BRITISH GLIDING ASSOCIATION

TECHNICAL COMMITTEE

TNS 6/7/81

1. AIRWORTHINESS AGGRO (Please add to 1981 Pink Pages)

Blatt/Page 4005-2 Ausg./Ed. 4.5.81

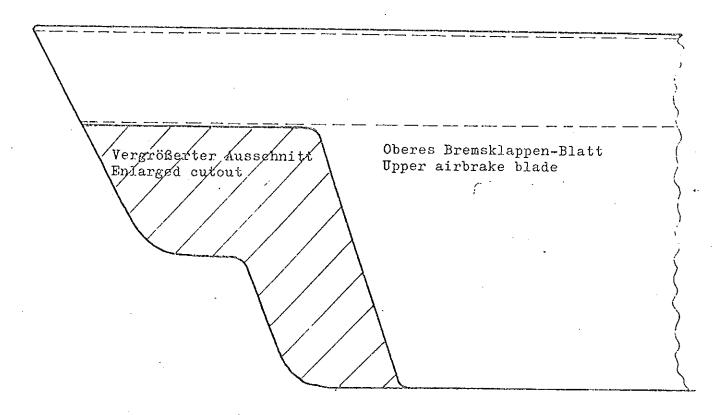
- 1.5. <u>LS4 AIRBRAKE</u> (cannot always be retracted beyond 200 Km/h.) Tech. Bulletin NR. 4005 (herewith), requires enlarging of the cut-out of the upper airbrake blade on the inner side, according to DWNG 4005-2.

Mit Hilfe der unten angeführten Zeichnung wird die Form des Ausschnitts an beiden Bremsklappen innen mit einem Bleistift angezeichnet und mit einer Metallsäge ausgeschnitten. Die Schrittkanten werden nachträglich mit einer Feile geglättet.

According to the drawing below the contour of the cutout is marked by a lead pencil and is cut out by a metal saw. The cutting edges are smoothed by a file.
